VALERO IMPROVEMENT PROJECT

Addendum to VIP EIR

Prepared for
City of Benicia

June 2008

Figure 2.3-2 VIP Amendments Equipment Locations

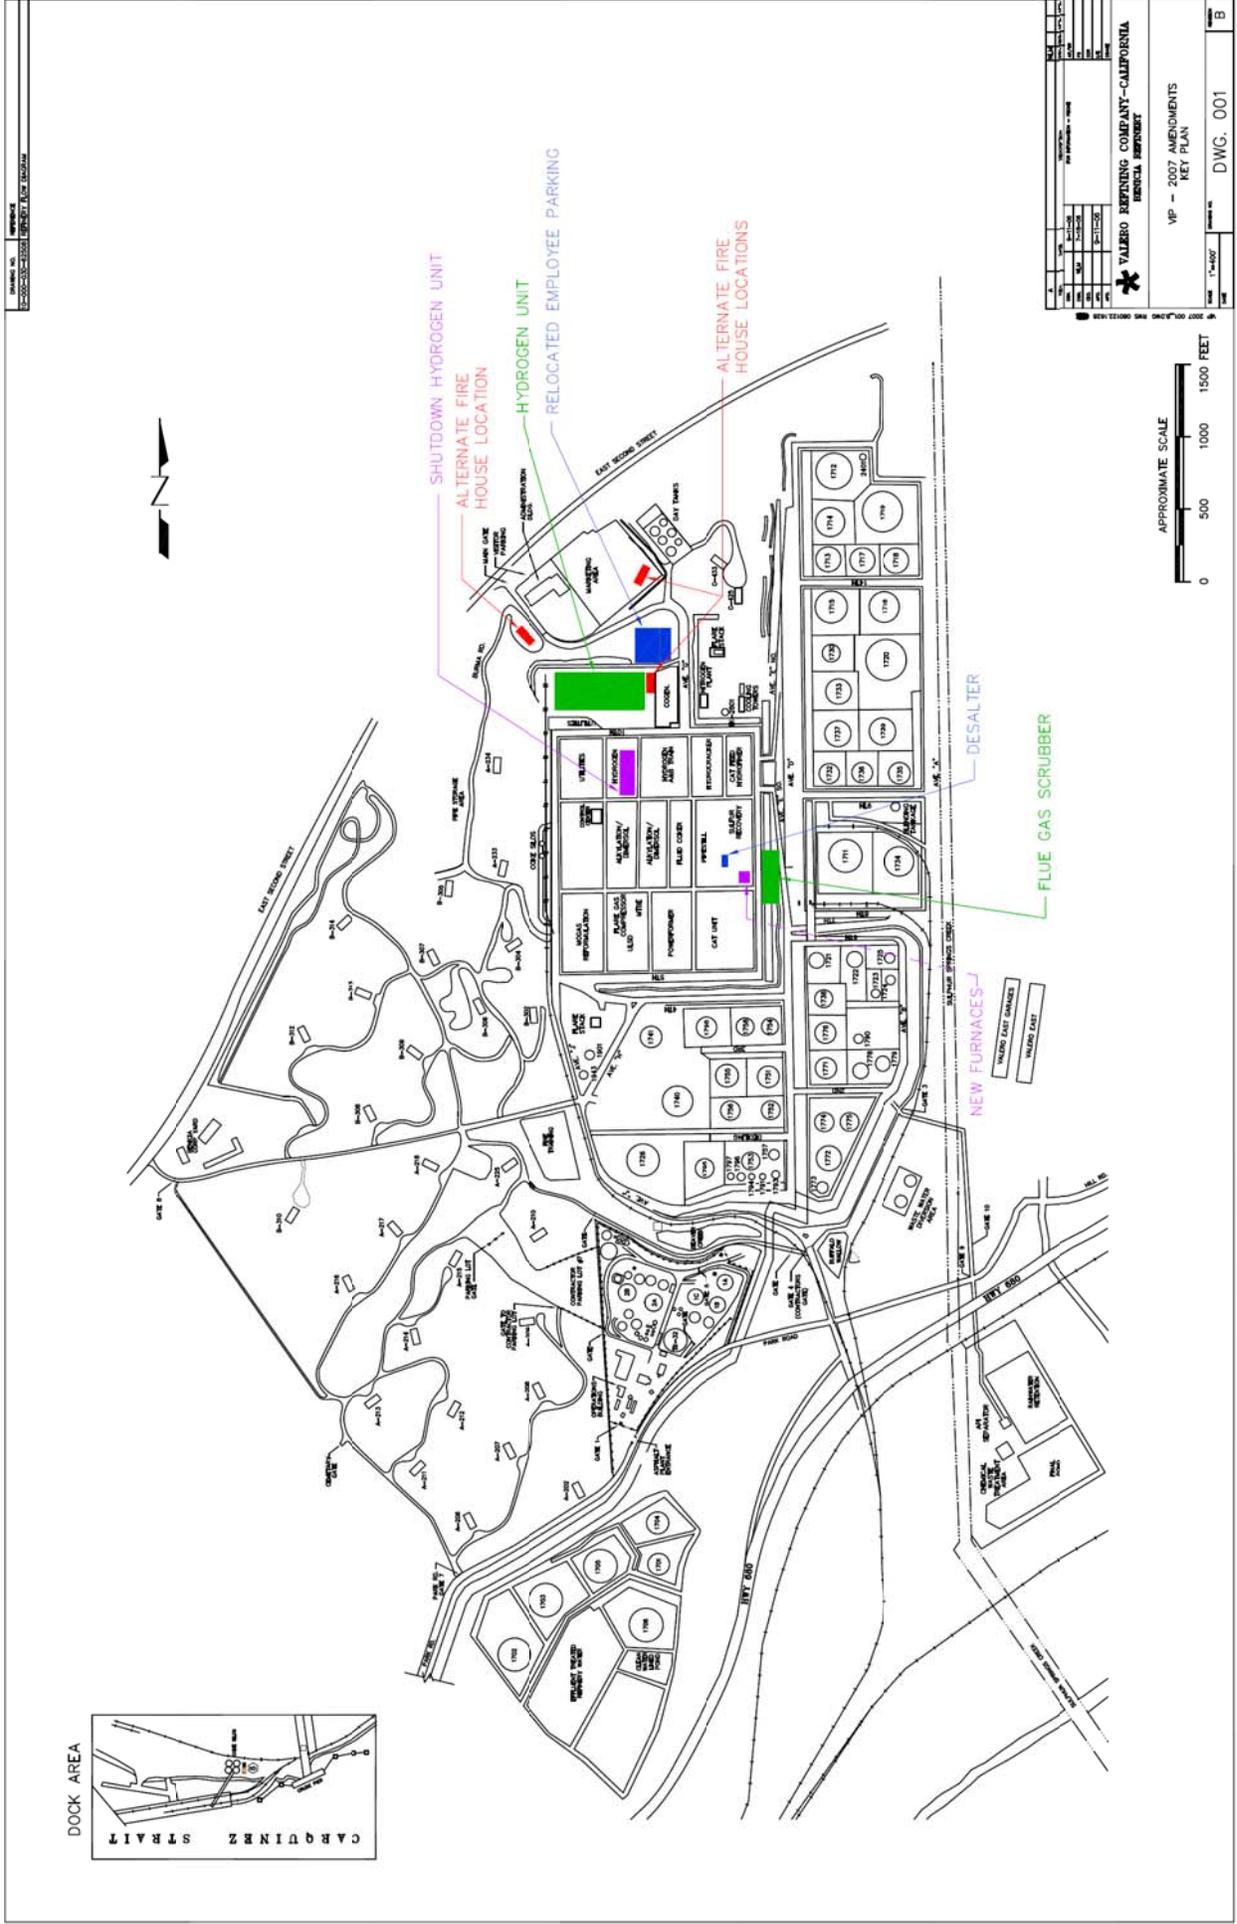
Locations of the individual project components within the Benicia Refinery property are shown in **Figures 2.3-2** and **2.3-3**. **Figure 2.3-2** displays the project locations on a plot plan drawing where the various refinery process units are clearly outlined. This figure identifies locations of major project equipment for each project component. It should be noted that some equipment shown in **Figure 2.3-2** is currently permitted and is not part of the revision proposed by the VIP Amendments; however, they will be constructed based on the project schedule presented in the VIP Amendments.

The FCCU/CKR Scrubber, including SCR units and waste heat boiler, will be installed on a new 150,000 square foot pad, constructed adjacent to the Refinery Process Block as shown on **Figures 2.3-2 and 2.3-3**. The site for the scrubber is currently sloped. The area will be cut and filled and retaining walls added to create a benched elevation of 57.5 ft. above sea level, which is 39 feet below the elevation of the rest of the Process Block. The top of the scrubber stack will therefore be 207 feet above the level of the process block. An alternate installation scheme is being considered that will install a retaining wall on the east side of the sloped area, which will then be filled and compacted to create a scrubber equipment pad at about the same elevation as the Refinery Process Block. In this installation, the top of the FCCU/CKR Scrubber stack will be about 245 feet above the Refinery Process Block.

Figure 2.4-3 VIP Amendments Hydrogen Production Configuration

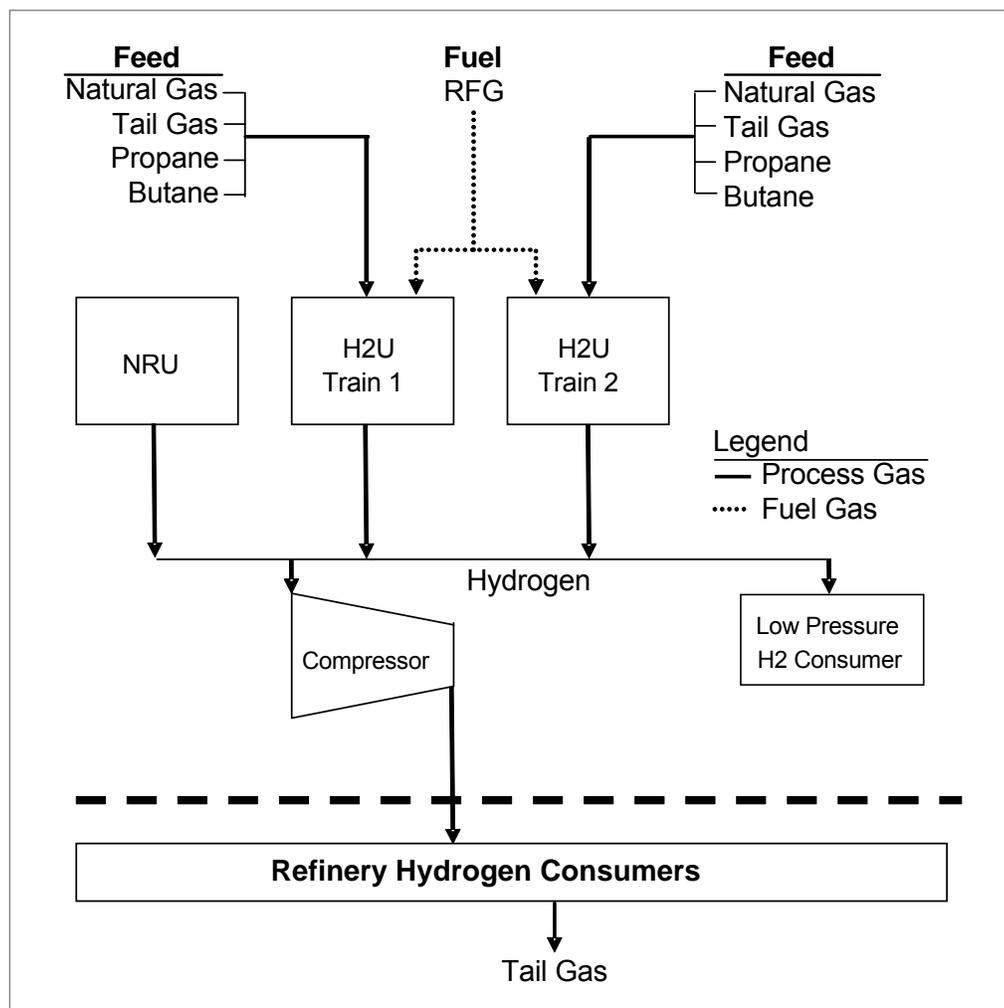
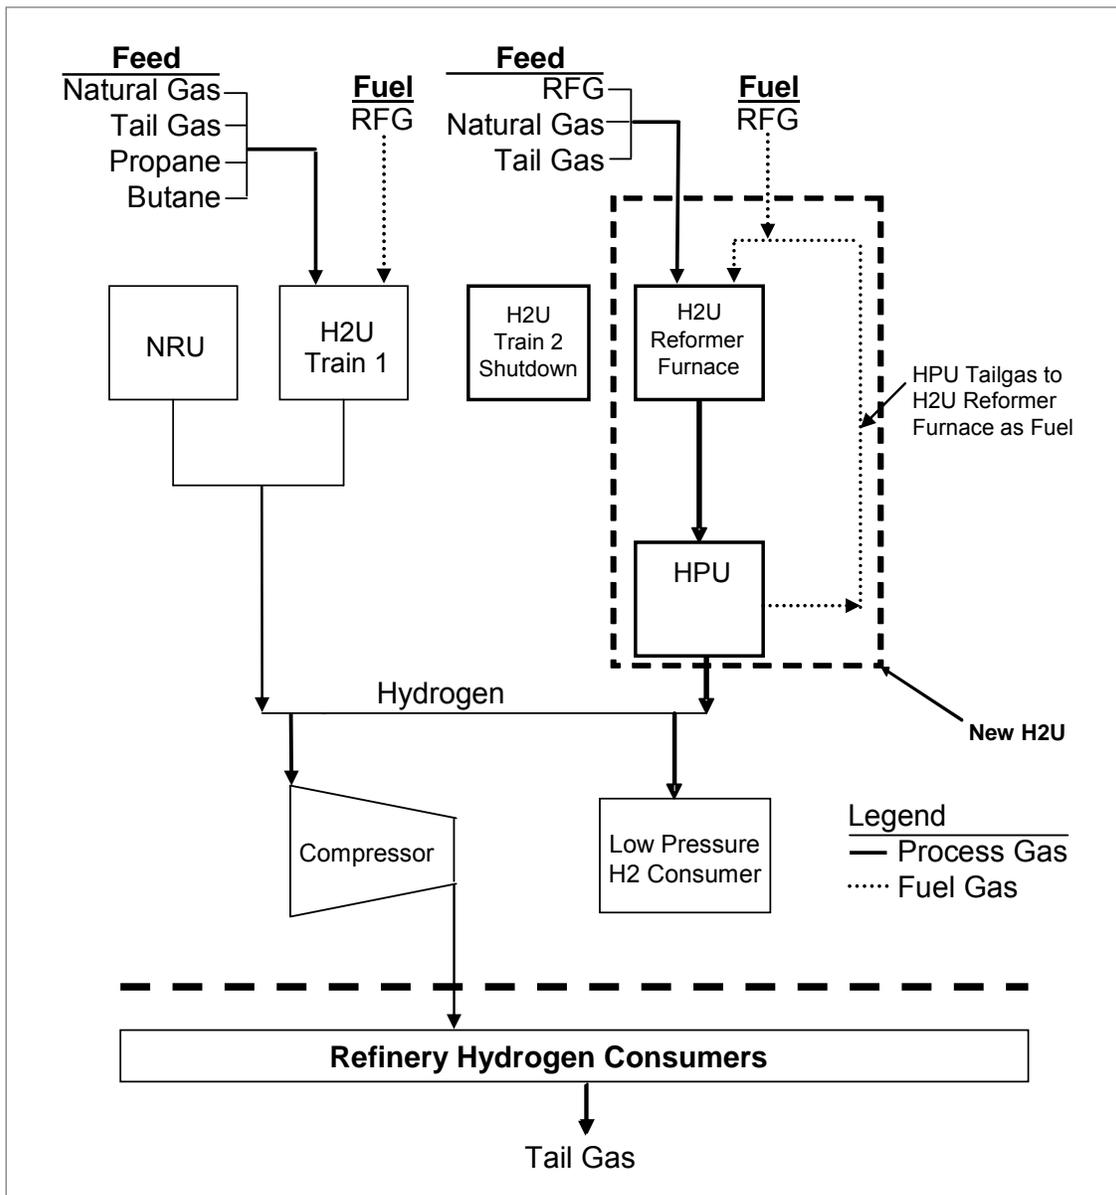
The currently approved VIP Use Permit provides for an increase in production of an existing hydrogen unit (H2U) and installation of a Pressure Swing Adsorption (PSA) Unit for improved hydrogen purity. In order to capitalize on improved energy efficiency inherent in more modern technology, Valero now plans to shut down one of the two trains of the existing H2Us and construct a new H2U. Benefits of the new H2U include greater system efficiency, decreased emissions per unit of hydrogen produced, and decreased consumption of commercial natural gas in favor of consuming RFG as the feed stock for producing hydrogen.

The existing hydrogen production configuration is depicted in **Figure 2.4-2**. **Figure 2.4-3** illustrates the proposed hydrogen system configuration, including the new H2U. The H2U block represents the new H2U and contains its own dedicated downstream PSA unit or other hydrogen purification technology. The resultant hydrogen from the existing H2U and the new H2U is used in a variety of process units throughout the Benicia Refinery to remove impurities from process intermediates and finished products.

Figure 2.4-4 Simplified Process Flow Diagram for Desalter

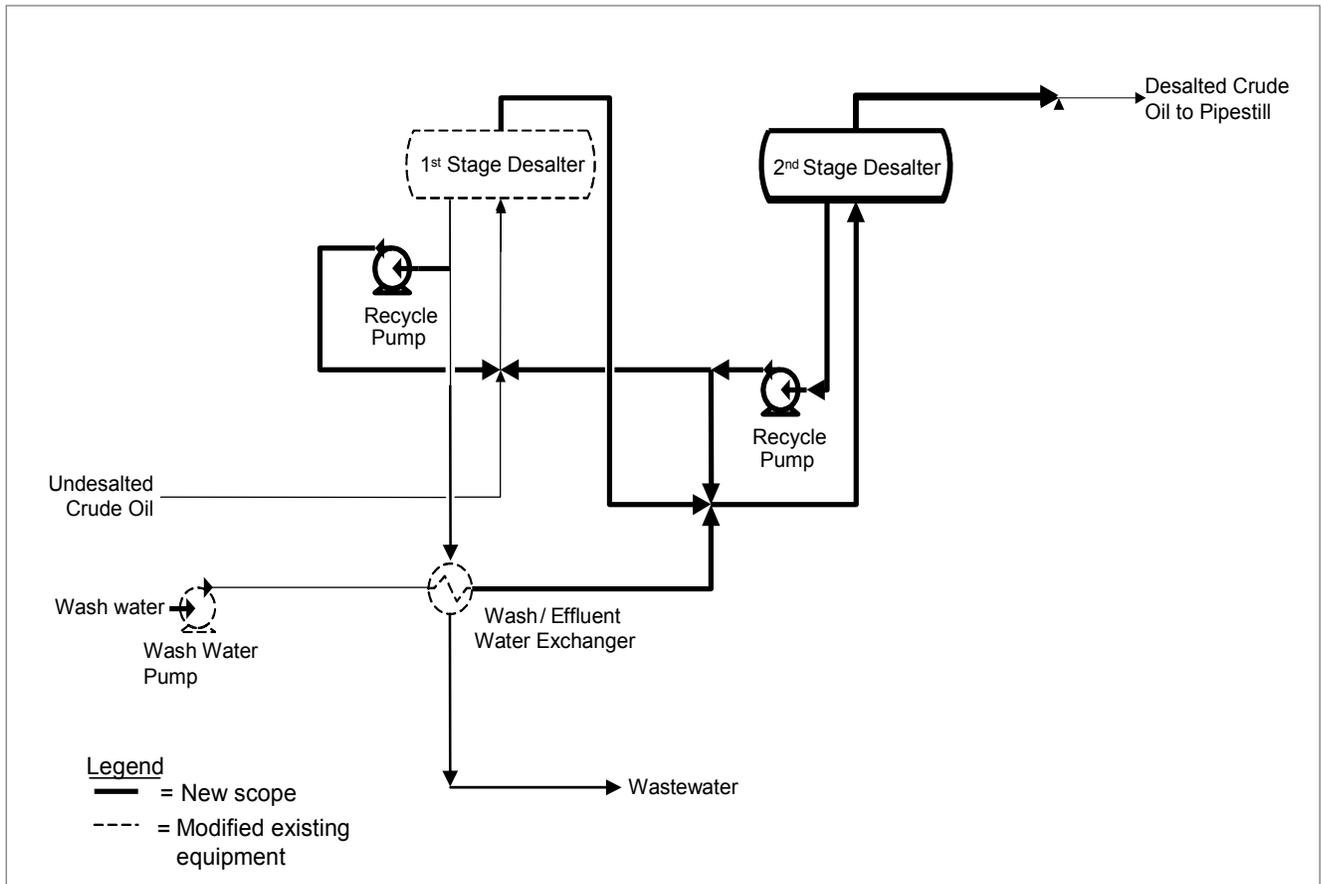
Figure 2.4-4 displays a simplified process flow diagram of the existing Benicia Refinery desalting process with the addition of the new second-stage desalter vessel. The figure illustrates the counter-current flow of wash water and crude in a two-stage desalting system. Wash water flows first to the second stage desalter where it is contacted with crude flowing from the first stage. Wash water from the second stage desalter loop is used to supply make-up to the first stage wash loop. Water from the first stage is blown down to wastewater treatment. This configuration provides improved removal of salts relative to the performance of a single stage. This is because the bulk of the salt in the crude coming into contact with low-salt content wash water in the second stage desalter has already been removed in the first stage. As the driving force for transfer of salt from the oil phase to the water phase is salt concentration, salt removal is increased with little or no increase of water. This configuration, known as a “staged cascade”, is a common technique for improving the efficiency of extraction in chemical processing.

Figure 3.1-1 Horizontal View Schematic of VIP Amendments

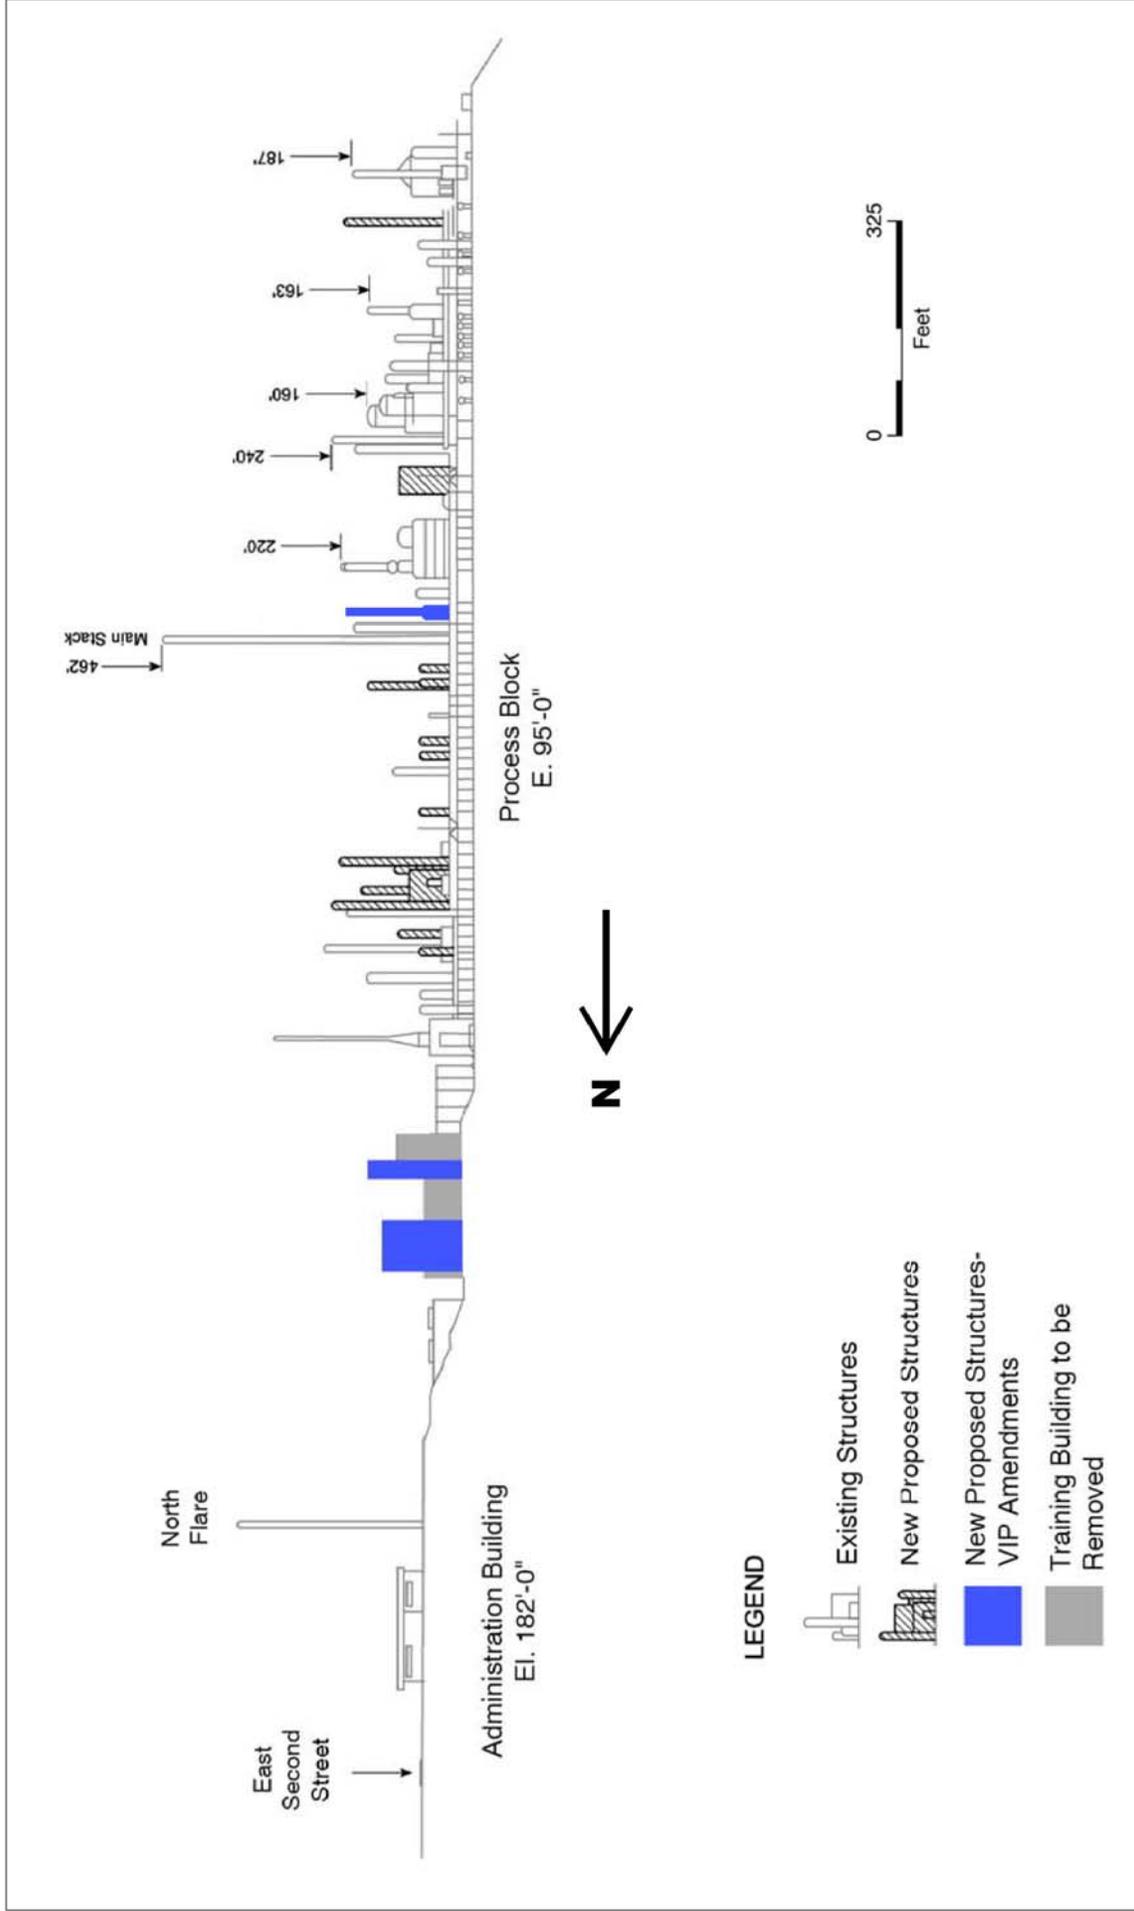
Figure 3.1-1 shows a horizontal view schematic of the major pieces of equipment proposed in the Certified EIR and the equipment changes associated with the VIP Amendments, e.g. installation of a new H2U and FCCU/CKR Scrubber. The FCCU/CKR Scrubber is depicted in its proposed location on a terraced area 39 feet below the Process Block. If the alternate siting at the level of the Refinery Block is considered, the top of the stack would be 39 feet taller than what's depicted in Figure 3.1-1. At 245 feet above the refinery block elevation, the FCCU/CKR Scrubber alternative would still be significantly lower than the Main Stack, and within the general range of heights of the existing structures.

The tallest components of the equipment included in the VIP Amendments are the stack for the FCCU/CKR Scrubber, the new H2U, and, and associated HPU components. Due to intervening terrain, none of these structures would be visible from the Morrow Lane to Benicia Bridge segment of I-680 or from the Caltrans vista point. Thus, since the VIP Amendments would not alter existing views from the designated scenic viewpoints by adding any visible new structures, no impacts to scenic vistas are anticipated.

Figure 3.1-9 Simulation view (VIP and Amendments) from Addison Court looking southeast

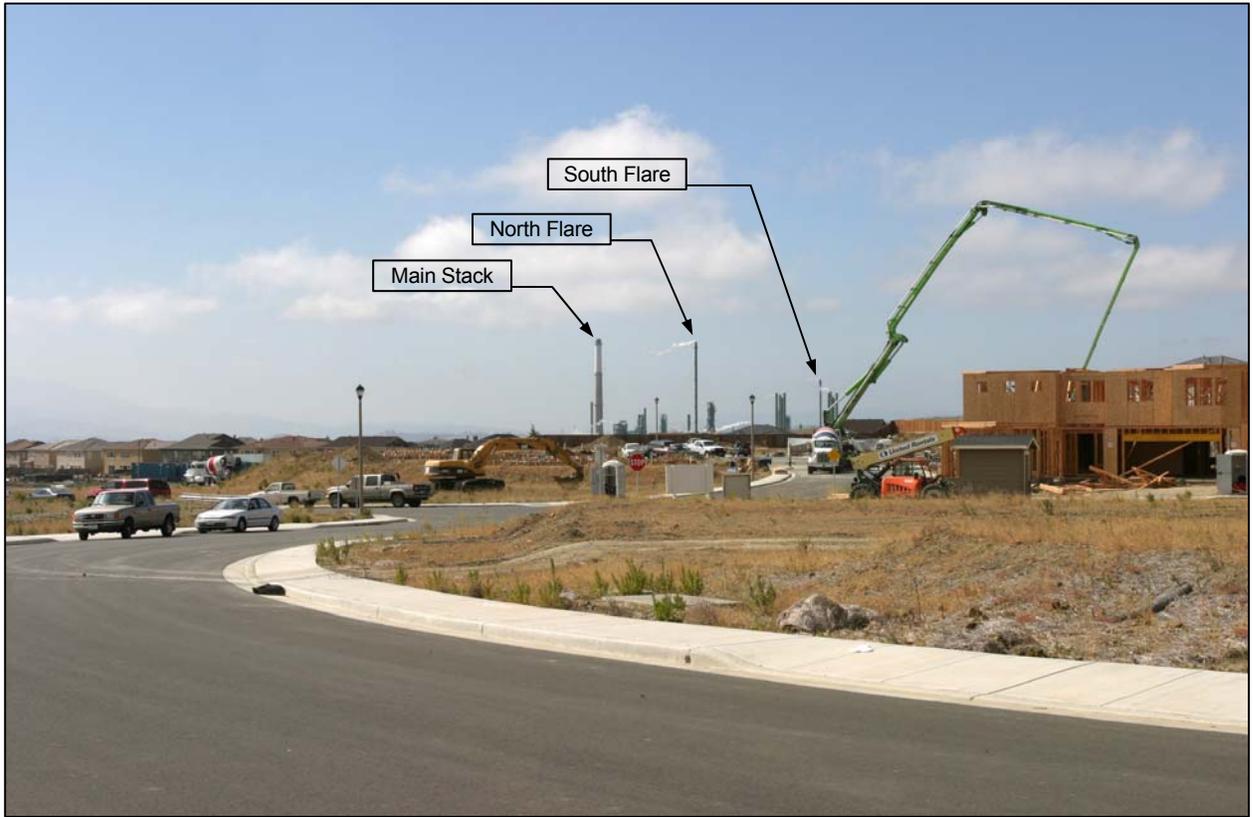
Figure 3.1-8 depicts a view from Addison Court, within the Southampton housing development, a location not evaluated in the Certified EIR. This viewpoint looking southeastward from Addison Court toward the Benicia Refinery Process Block is from the public right-of-way of Addison Court. As shown in the figure, the viewpoint location area is currently being developed with single-family residences. Currently, portions of the Refinery Process Block are visible from this location, though it is not as prominent as the view seen from other viewpoints evaluated in the Certified EIR. This is due to the larger geographical distance between Addison Court and the Refinery Process Block, when compared to the distances from other evaluated viewpoints to the Refinery Process Block. As depicted in the computer simulation in **Figure 3.1-9**, the FCCU/CKR Scrubber and H2U would be visible from this viewpoint. Although not included in the simulation, the alternate FCCU/CKR Scrubber, at 39 feet taller, would be similarly visible. However, once the residences in this area have been constructed, it is highly likely that view corridors from this location would be such that publicly accessible views of the Refinery Process Block would be blocked to a greater degree than is the case under existing conditions. Under future residential buildout conditions, views of the Refinery Process Block would include the tops of refinery vertical stacks and most likely would not include views of the FCCU/CKR Scrubber at either of its elevations, or the H2U.

EA Figure 3.1-8 depicts a view from Addison Court within the Southampton housing development. Since Figure 3.1-8 (EA pages 3-11 and 3-12) was created, more residences in the Southampton housing development have been constructed between the viewpoint and the Refinery Process Block, further blocking publicly accessible views of the Refinery Process Block. Views from this location are now limited to intermittent views of the Refinery vertical stacks between the new housing development, as well as the tops of a few Refinery vertical stacks that extend beyond the new developments.
